# SERVICE No. 1041 BULLETIN

**Distribution of Airborne Service Letter Number 56,  
“Inspection and Cleaning of Airborne Air Filter Elements”**

**Service Letter Number:** 56

**Subject:** Inspection and Cleaning of Airborne Air Filter Elements.

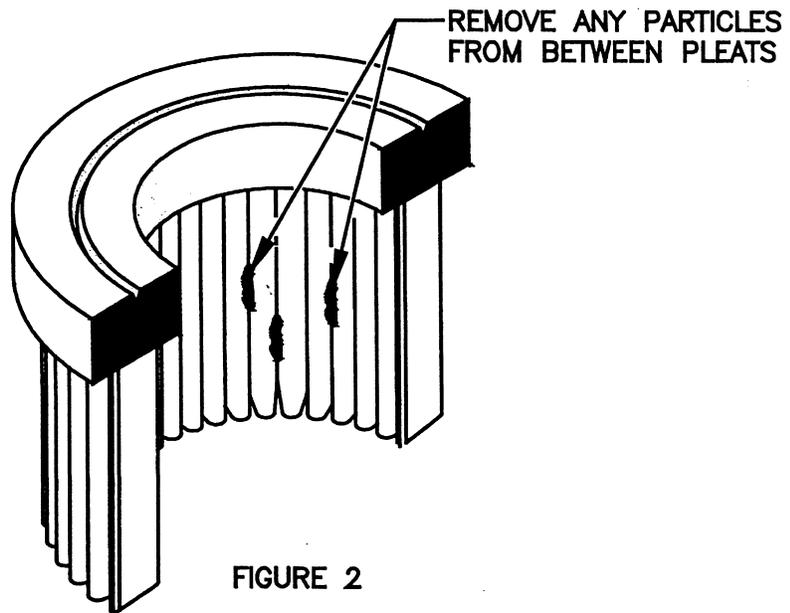
- 1) Remove the affected air filter element from aircraft per the instructions outlined in the appropriate maintenance/service manual provided by the airframe manufacturer.
- 2) Inspect the inner diameter of the black end piece(s) of these elements for flashing (Figure 1). Remove all flashing using a sharp knife. Caution: Do not cut the paper filter portion of the element.

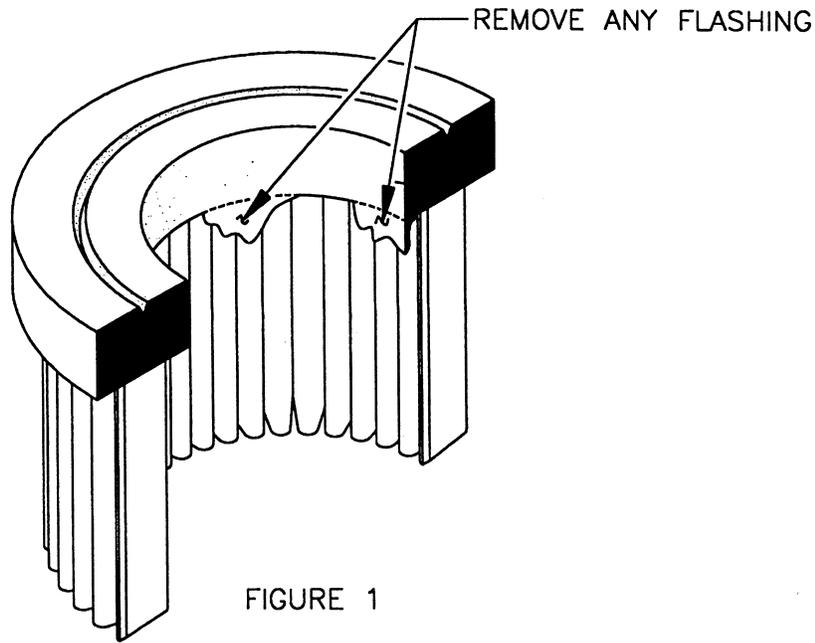
- 3) Tap the element lightly on a clean work surface in order to remove any loose particles from between the pleat tips on the inside of the paper filter (Figure 2).

FIGURE 3

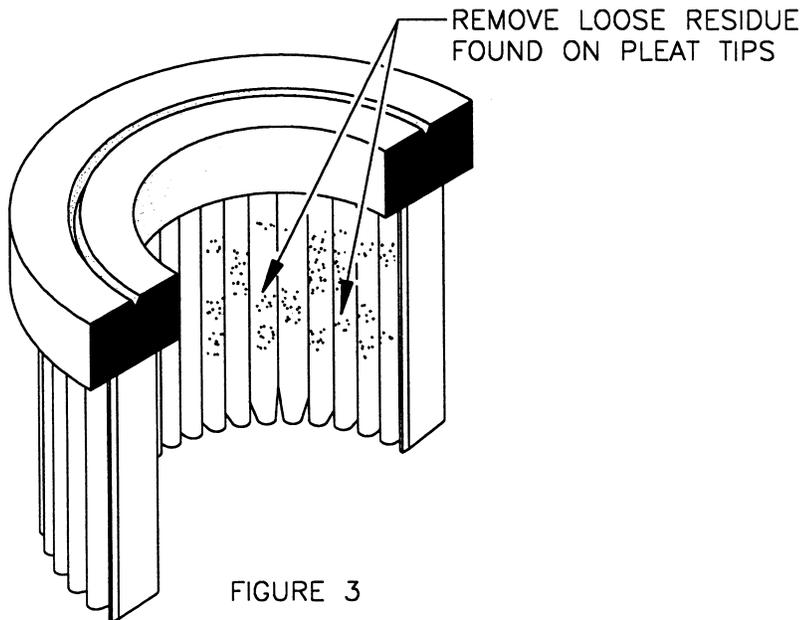
- 4) Inspect the inner diameter (pleat tips) of the paper filter for black residue (Figure 3). Remove all loose residue using the "sticky side" of a strip of masking tape attached to the end of a blunt instrument.

FIGURE 4

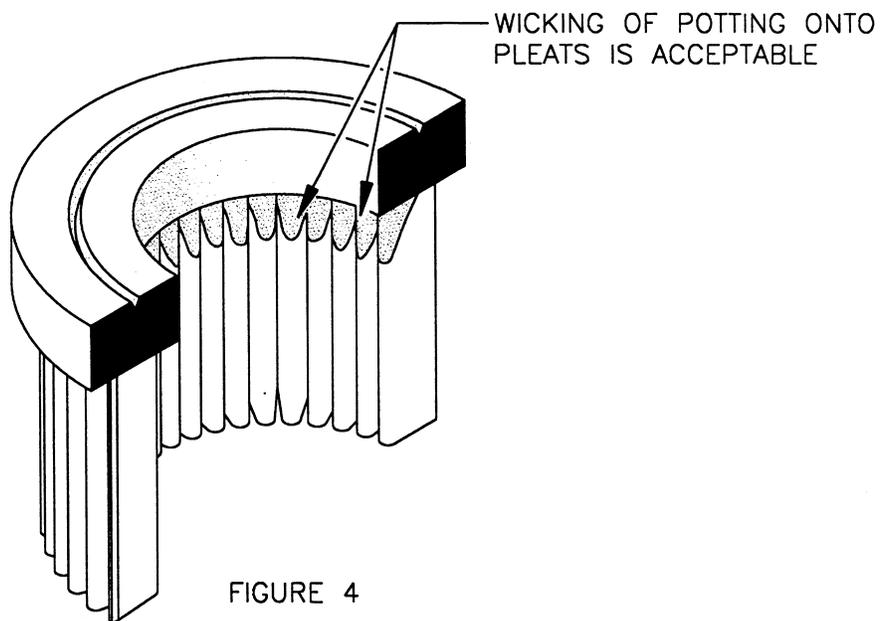
- 6) Thoroughly inspect all internal surfaces of the element for any loose particles. Remove any remaining loose particles using any combination of the above steps. Note: The wicking of black potting material onto pleats of paper filter is acceptable (Figure 4).
